1050223-002-AV

Re: Tiger Bay Duct Burner

✓ **1. Comment # 1:** Page 2. The Title V application (Facility Regulatory Classification) indicated that the facility was not a major source of HAPs. To the best of our knowledge, the facility classification has not changed.

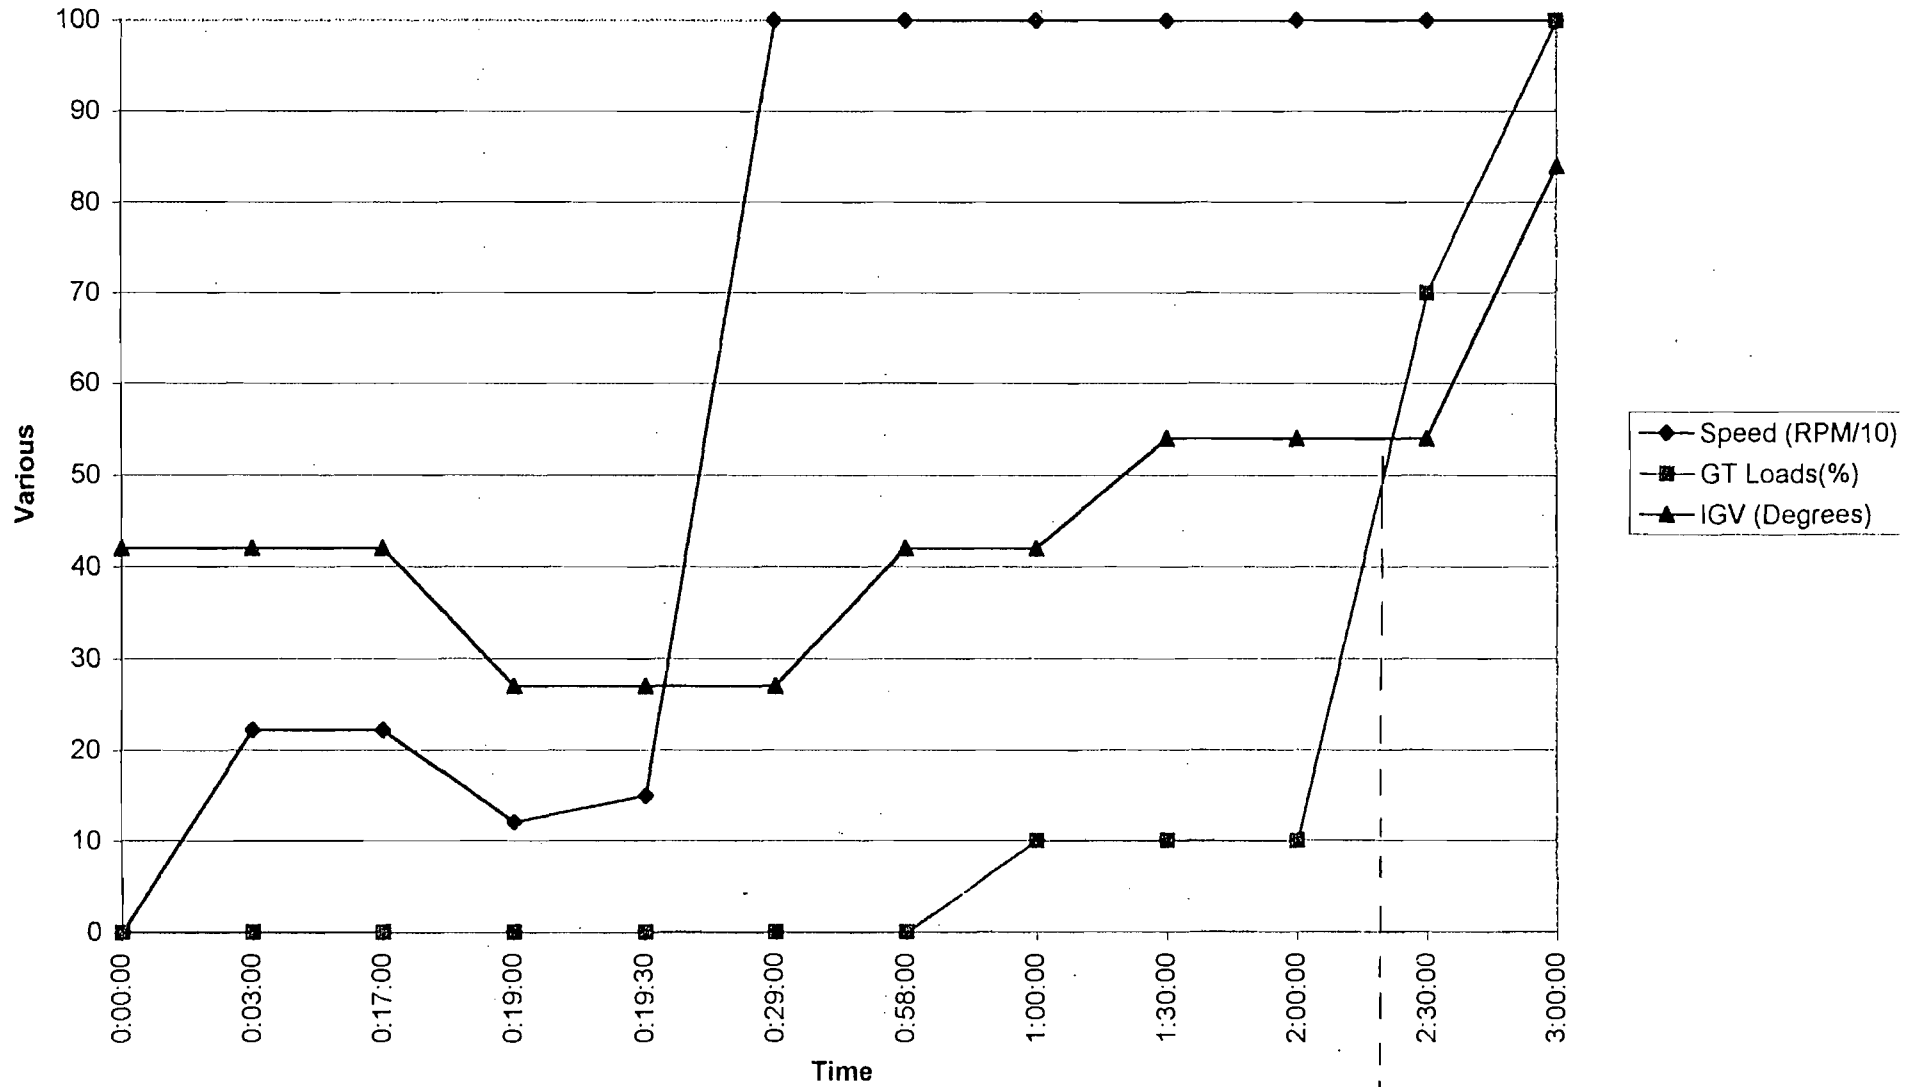
✓ **Comment # 13:** Page 11. Condition A.35. In accordance with the attached start-up curve, FPC requests that this unit be specifically authorized to have excess emissions for 3 hours (rather than 2 hours) in any 24-hour period, unless specifically authorized by the Department for longer duration. Also, the pertinent excess emission provisions of 40 CFR Part 60 should be included in this section of the permit, i.e., §§ 60.8(c), 60.11(c), and 60.43c(d).

Per your request attached please find a graph showing the start up sequence for the 7FA at Florida Power's Tiger Bay Facility. As we discussed the attached sequence occurs automatically after any gas turbine shutdown of 50 hours or more duration. General Electric has added this revised start up sequence (titled "Soft Start") to the gas turbine controls as a protective measure to minimize potentially damaging thermal stresses in the turbine rotor during a cold startup.

Of note is the long period at which the gas turbine operates below the steady state pre-mix mode (just over 2 hours from initial start up command). At loads below steady state pre-mix the combustion system is not capable of achieving 25 ppmvd NOx levels. Shortening of the cycle to get the turbine into steady state pre-mix sooner would offset the benefit of allowing the slower warm-up of the turbine rotor and may result in pre-mature failure of turbine components.

Response: *The Department disagrees with the comment. This is a quote of the rule. Are the sections from 40 CFR Part 60 applicable?*

*Appendix about 3 hr
startup also has to be
added. Condition can not be
added through TV - it's a
compliance issue.*
